The City of Spartanburg Board of Architectural Design & Historic Review

AGENDA

March 13, 2025, at 5:30 P.M.

1 SITE PLAN
A0 1/16" = 1'-0"

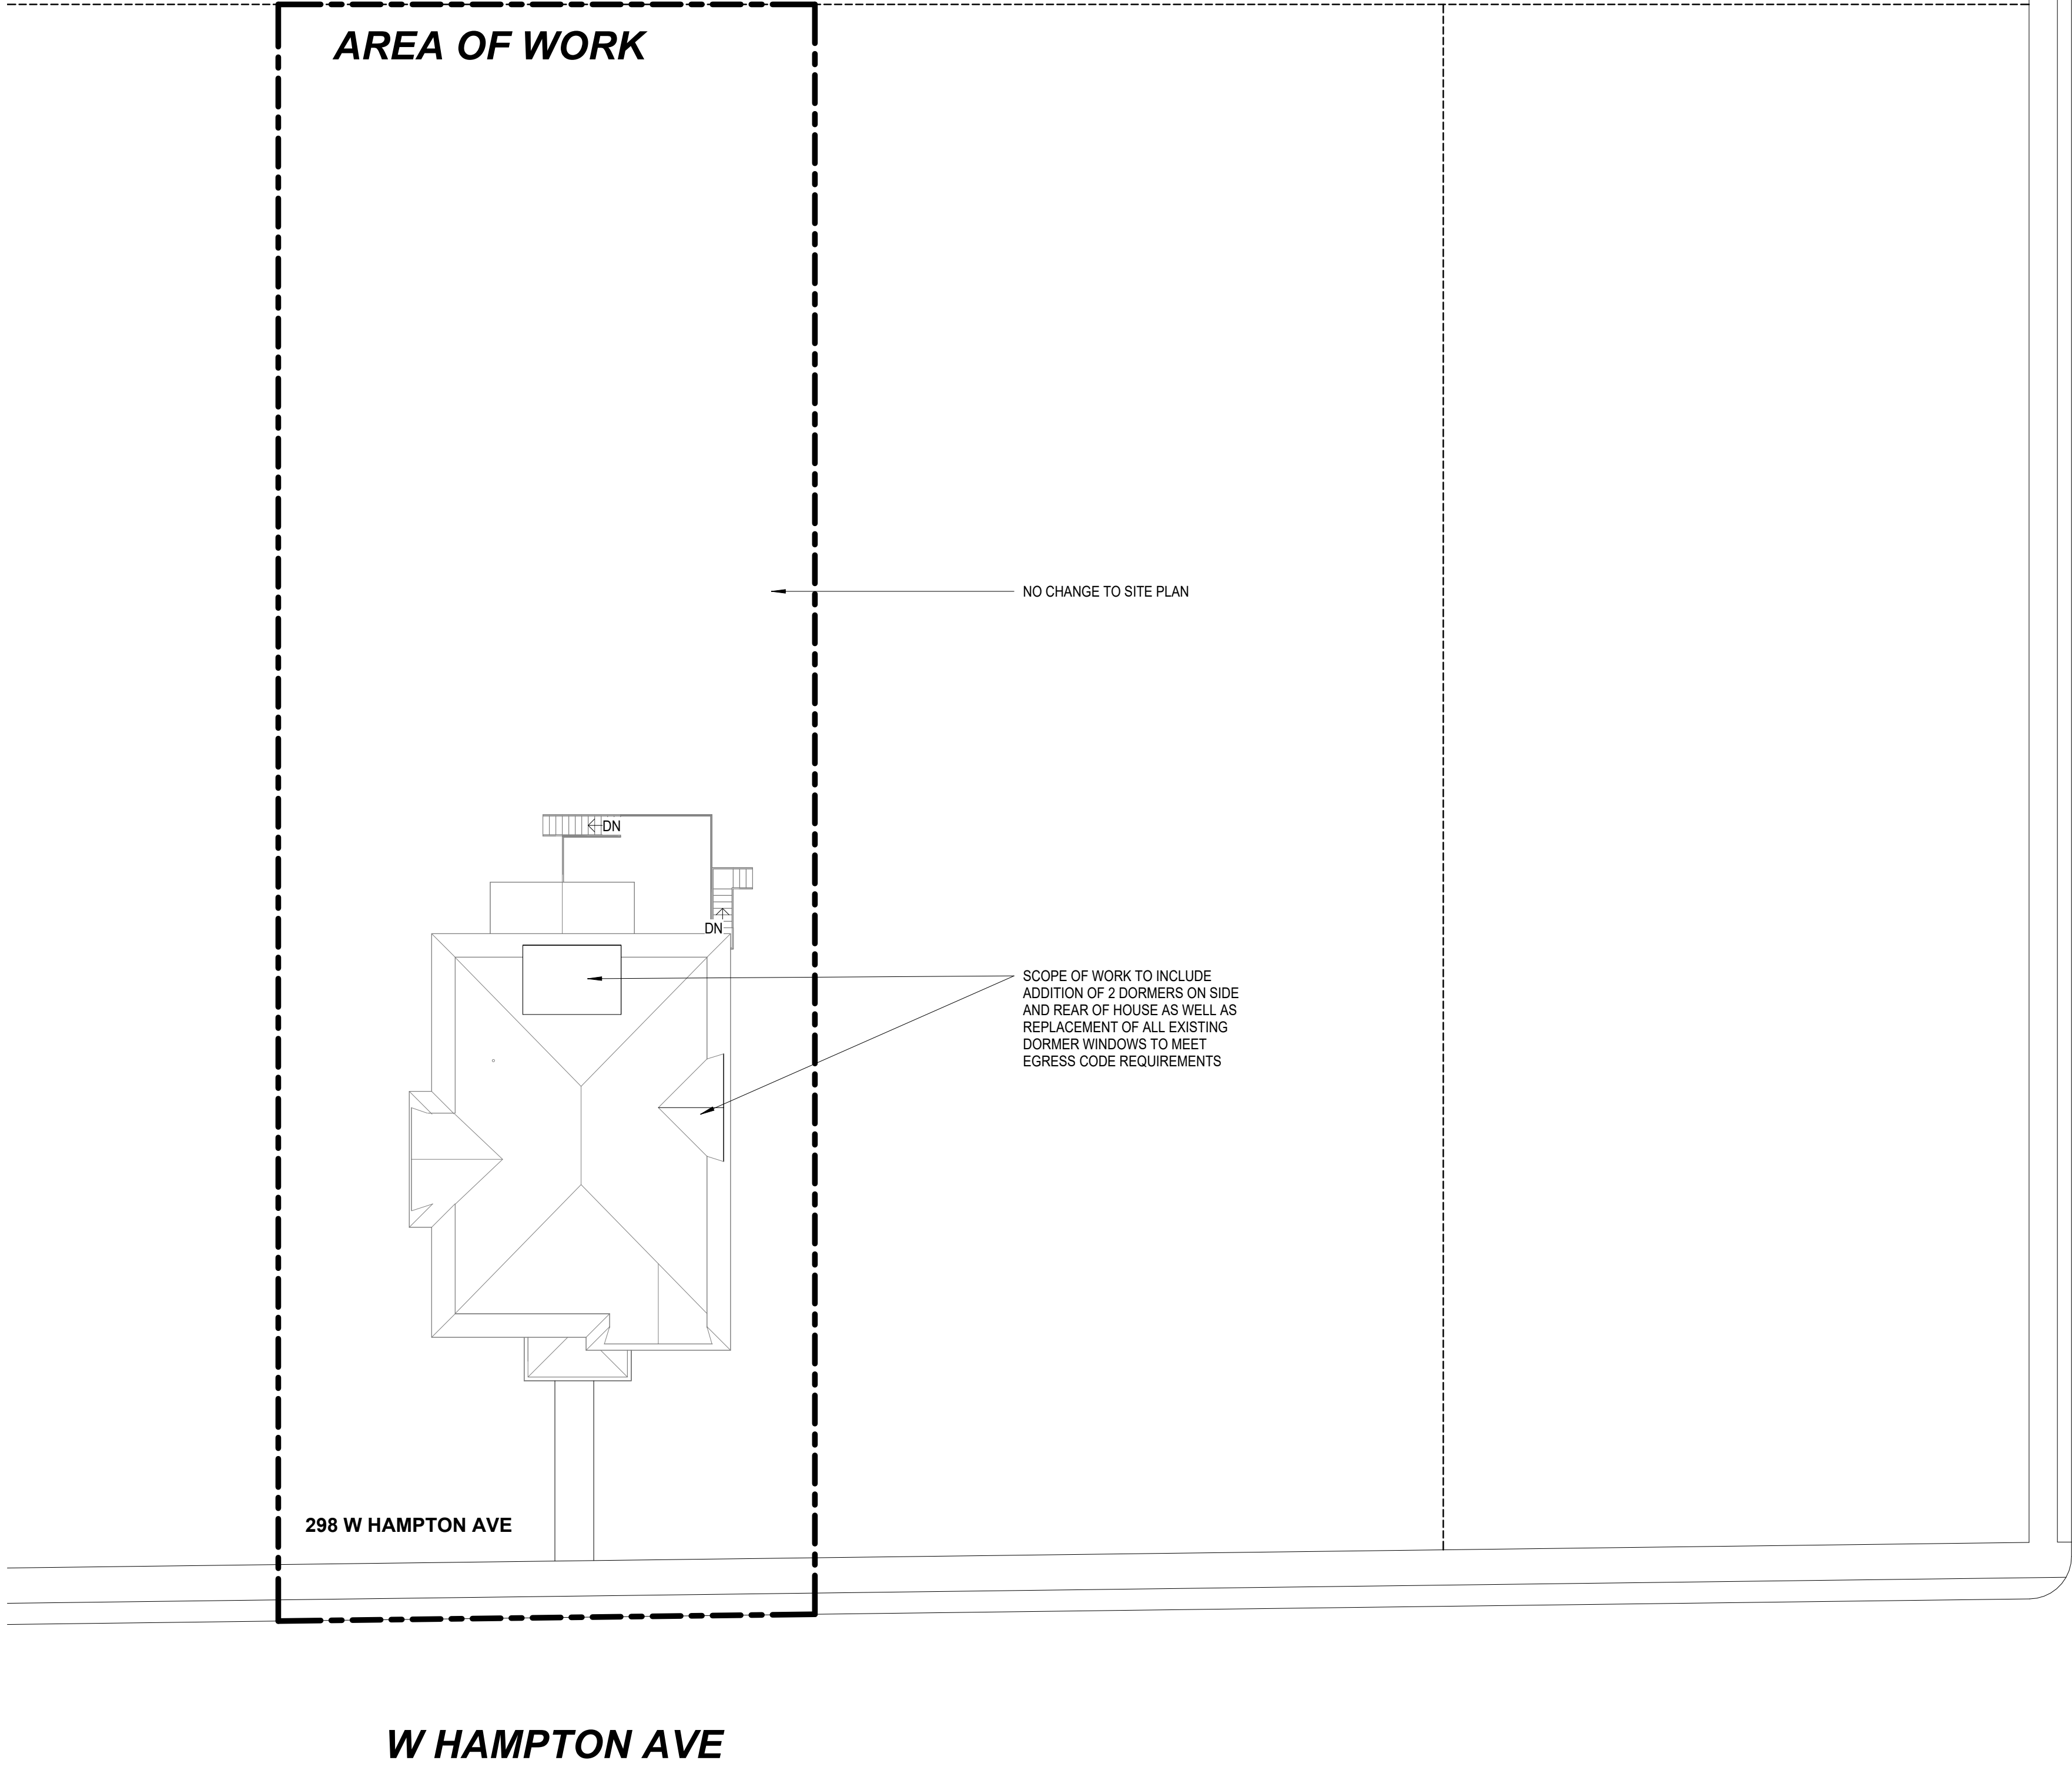
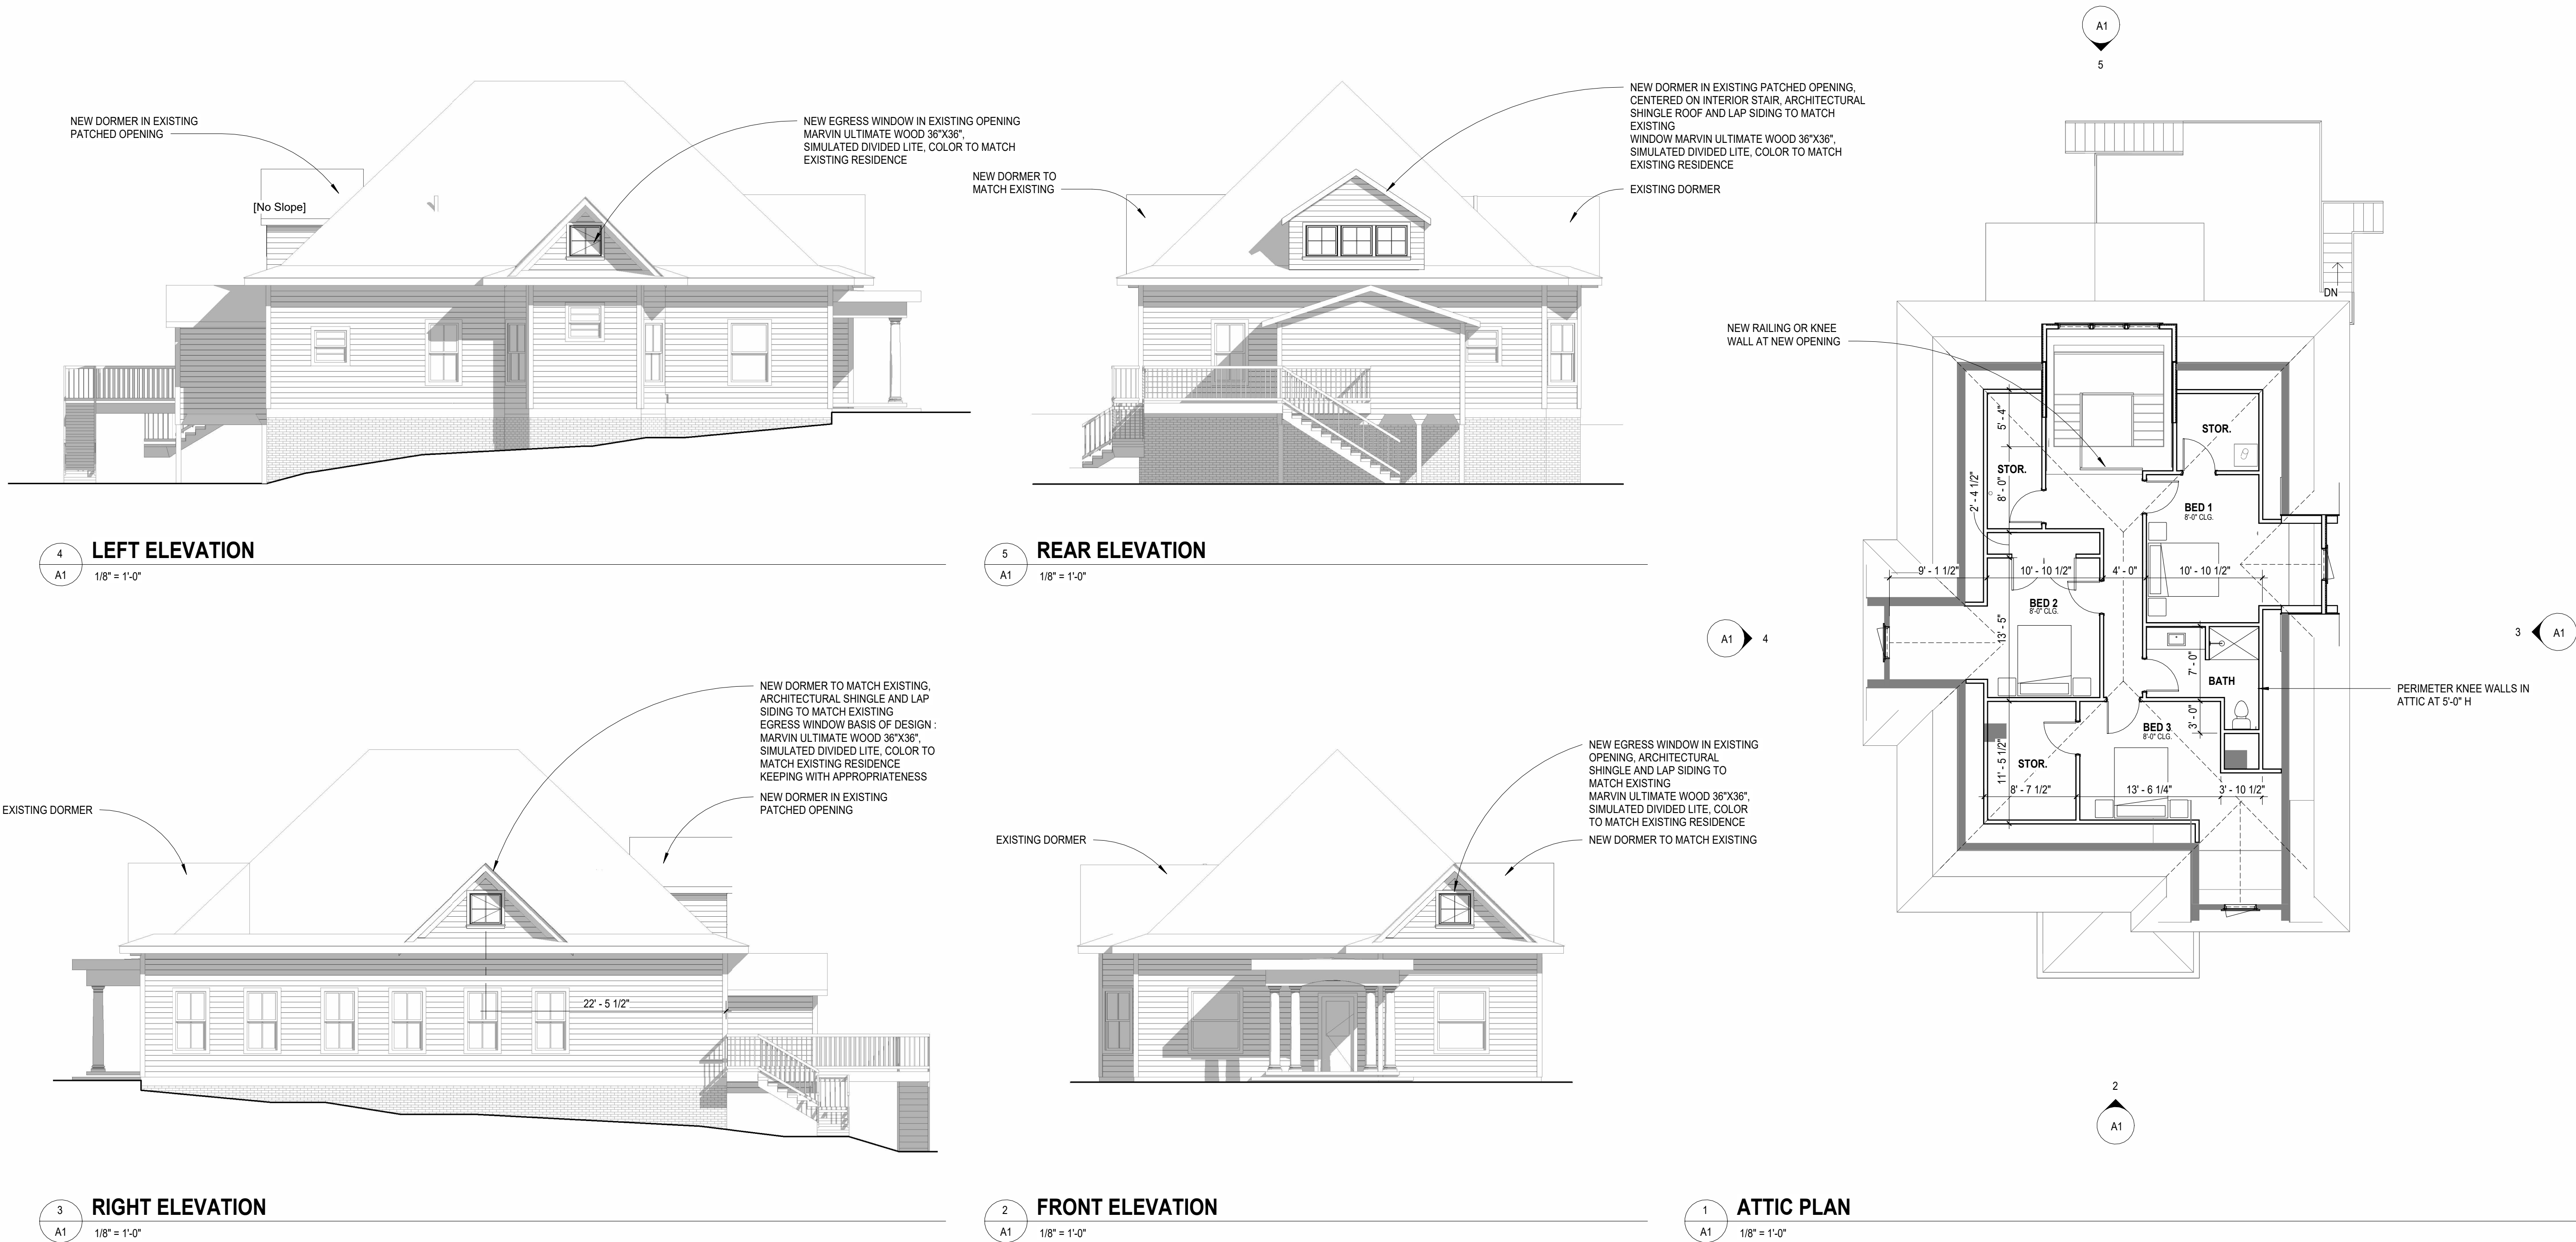
The applicant has requested approval to change the exterior appearance of the house on three sides that are visible from the public way. The design includes modifying the existing dormer windows on the south and west elevations as well as constructing a new dormer on the east side of the house. An additional new dormer that will not be visible from the street is proposed for the rear of the residence.

Image O Wood railing, Original railing unknown, basis of design based on railings for neighboring properties

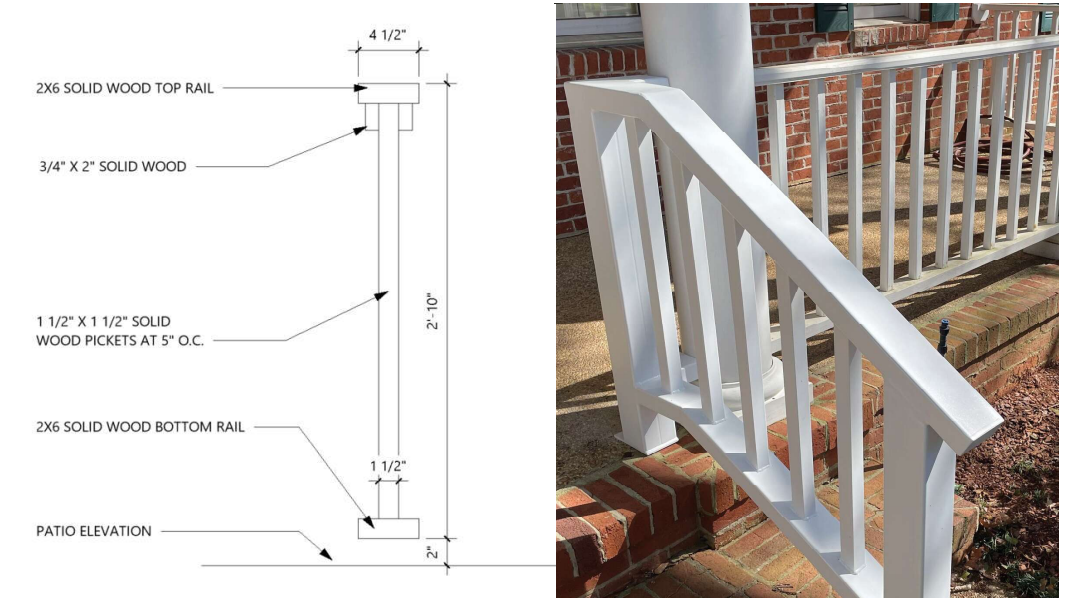
6. Flashing at roof to be repaired
9. New railing to replace existing. See image O for Basis of design
10. Exposed foundations to receive Sakrete concrete smooth troweled parge coat. See image P
11. Basement windows that have been bricked in to be replaced with metal windows to match original basement. Visible in image N

Image M Wood railing, Original railing unknown, basis of design based on railings for neighboring properties

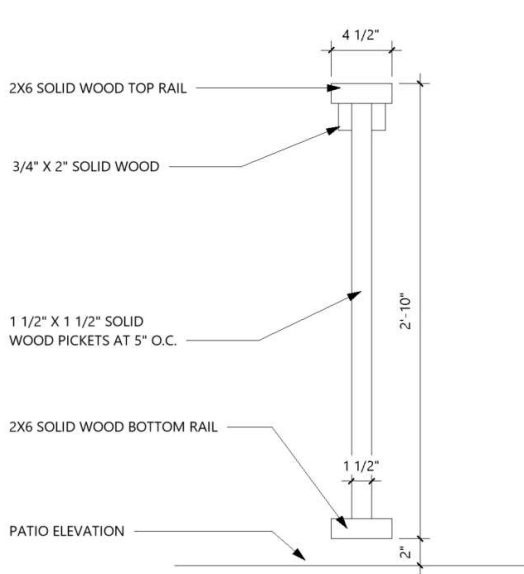
New wooden handrails have already been added to the steps which are at the rear of the house and are visible from the street. The pre-manufactured concrete steps are not original to the house, and it is likely they did not have handrails when they were originally installed. The Guidelines for Hampton Heights do not address the addition of new handrails where none existed previously, however, other guidance can be found that addresses the issue. The Guidelines for the Historic District for the City of Rock Hill, S.C. provide the following guidance: "The introduction of a new porch railing for a porch that was originally built without a railing is discouraged. If required for safety or access reasons, the railing should be simple in design with square balusters. Decorative wrought iron handrails or rails of other metal materials should not be installed. If handrails are desired, these should be of wood or metal in simple designs with square balusters and should be installed at the porch floor and sidewalks in order to eliminate damage to historic stairs and columns." Even though in this case there is no porch, the concept is the same. A simple metal rail would be a better fit since the steps are concrete and there is no other wood railing on the rear of the house. The applicant should submit information that describes the proposed rail for staff approval prior to installation.

- 5. Replace exterior entry lights. See image L for basis of design
- 6. Replace damaged rear entry door. See image K for basis of design. Option 1: Fiberglass door Option 2: Wood door
- 7. New gravel to be poured at existing rear parking area
- 8. New railing for rear entry. See image M for basis of design
